Circulation - All Rolls-Royce  
Franchise Holders

DELETION OF RIDE CONTROL

All Rolls-Royce Silver Cloud III cars and all Bentley S3 cars.

FIG. 1 EARLIER ASSEMBLY

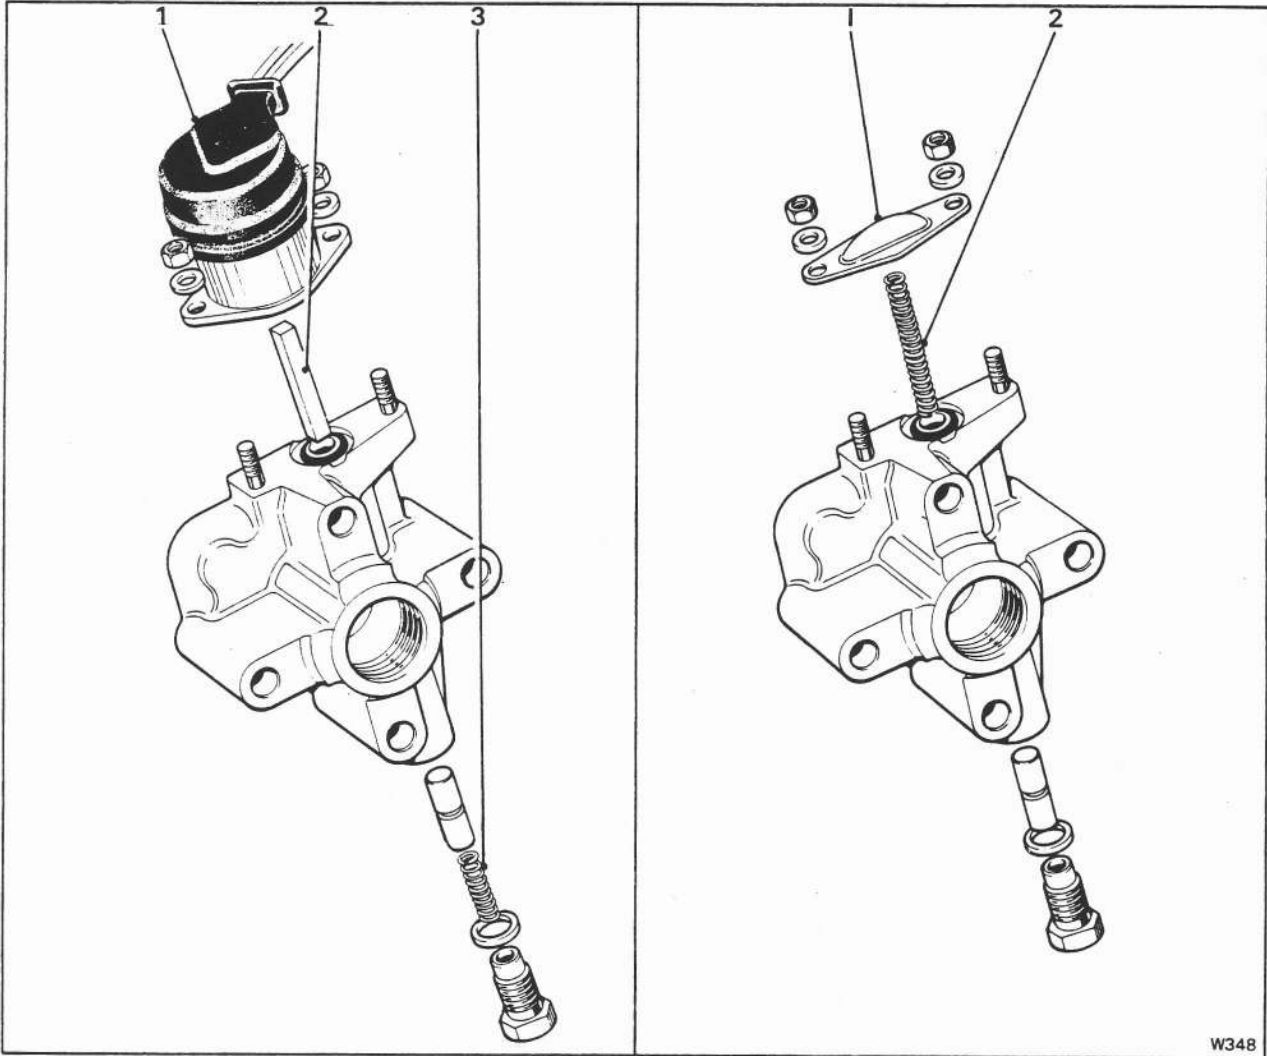
The rear damper solenoid, slow leak push rod and spring, have been discontinued. A new spring is fitted in place of the push rod and a blanking plate is fitted in place of the solenoid.

- 3 Disconnect both the wires to each rear damper solenoid and tape them back into the loom.
- 4 Remove the ride control solenoid (see Fig 1)
- 5 Remove the solenoid spring (see Fig 1)
- 6 Remove the slow leak push rod (see Fig 1)
- 7 Fit the new spring in place of the slow leak push rod (see Fig. 2)
- 8 Fit the blanking plate in place of the solenoid (see Fig. 2)

Part No.	Description
UR 1509	Blanking Plate
UB 15301	Spring
